News Flash

No. 55-29

October 17, 1955

ATTENTION: DEALER SERVICE MANAGER

Fig. 3 Late Type Shift Valve Body

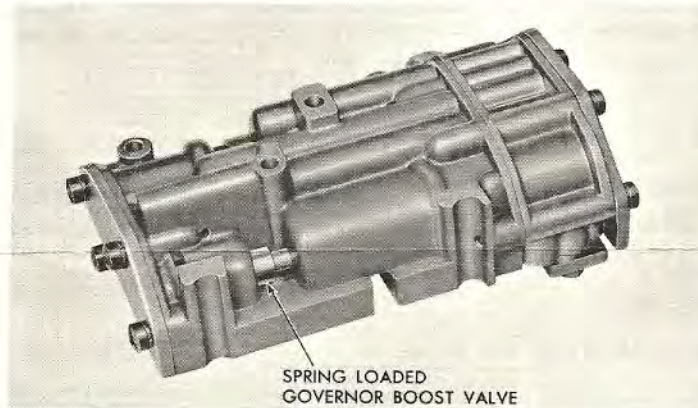
Service parts can be identified by the part numbers listed above. Visual inspection of the shift valve body on the transmission will show whether it is the 2nd type (with spring) or the 1st type (no spring). The valve will appear as shown in Fig. 3 on the 2nd type and the spring tension can be felt. On the 1st type the valve may or may not be visible, but it will be obvious that there is no spring tension.

Fig. 4 Late Type Coupling Valve and Springs

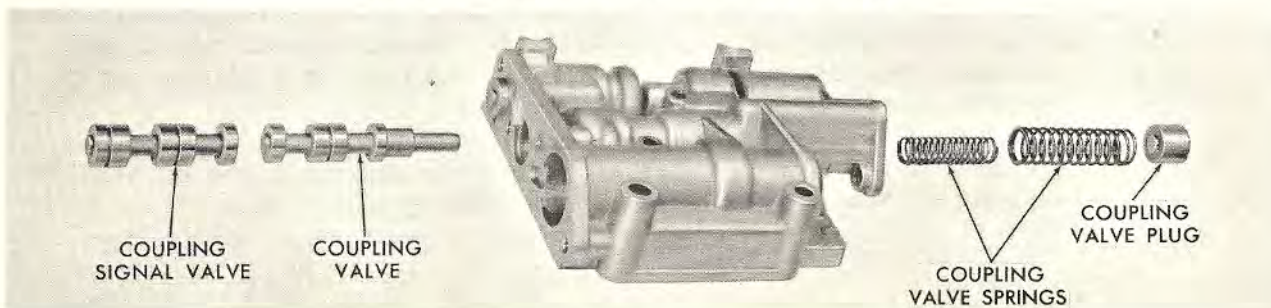
When it has been determined which type shift valve body is on a control valve assembly, it can be assumed that the overrun clutch valve body is of the same type. If necessary to determine the type of overrun clutch valve body, the only method is by removing the rear plate which compresses the limit valve springs. It can then be determined whether the coupling valve plug is the 2nd type and whether there are one or two coupling valve springs (Fig. 4).
